Transport
for NSW

Submissions Report

Modification to Showground Station
State Significant Infrastructure Approval (EIS 1)

26 February 2013

FIGURE 1-1: PROPOSED MODIFICATIONS AT SHOWGROUND STATION

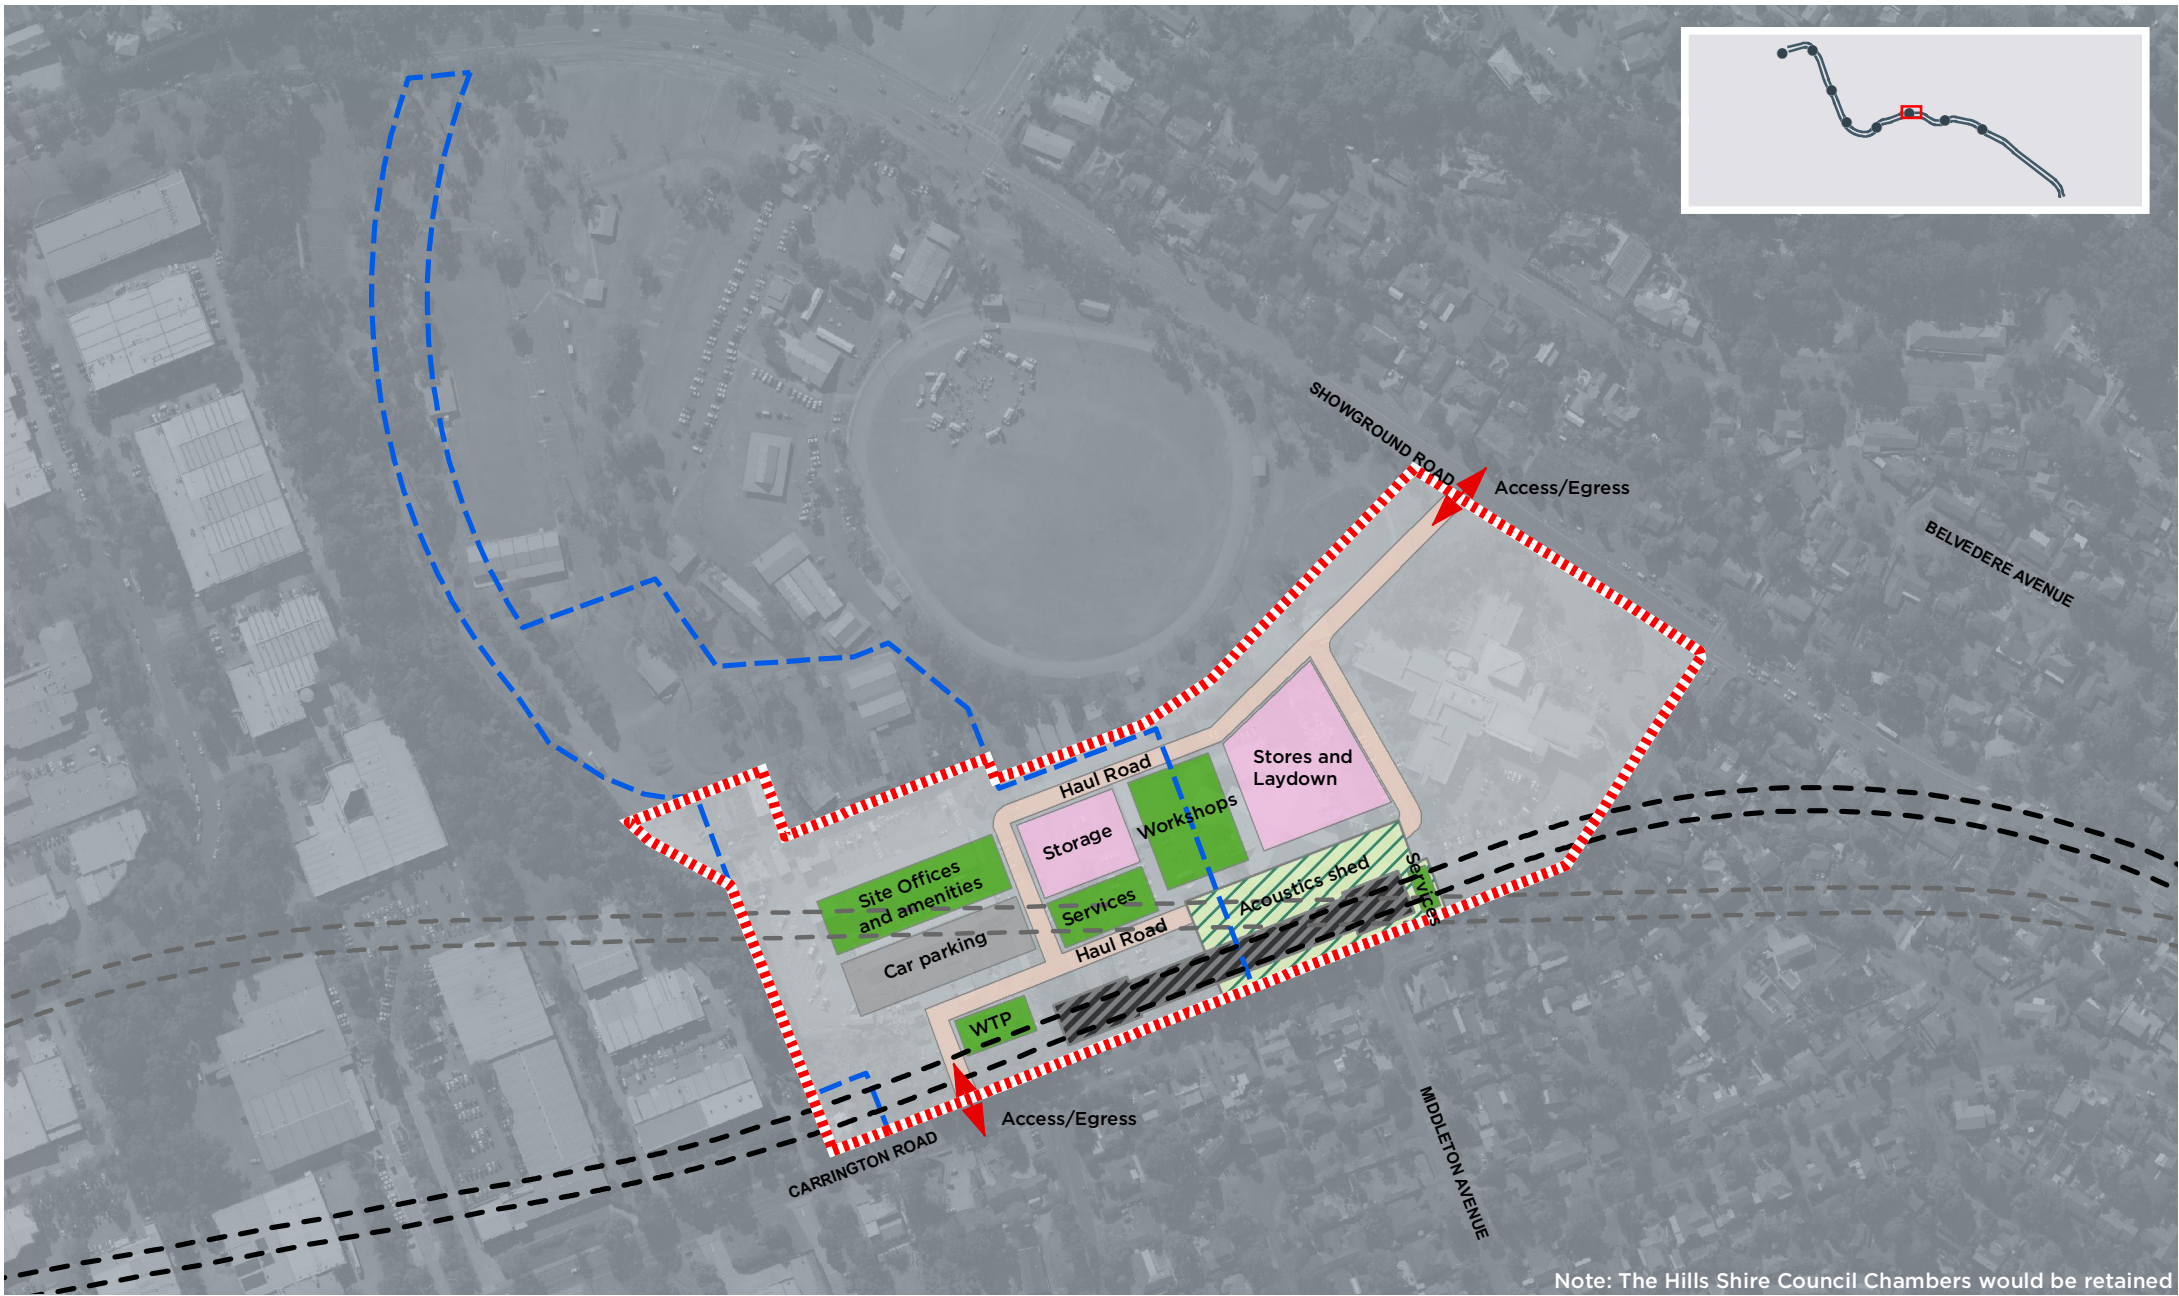
Construction traffic movements within the construction site layout will be restricted to designated haul roads (see Figure 1-1).

Construction worker parking within the construction site layout will be restricted to designated haul roads (see Figure 1-1).
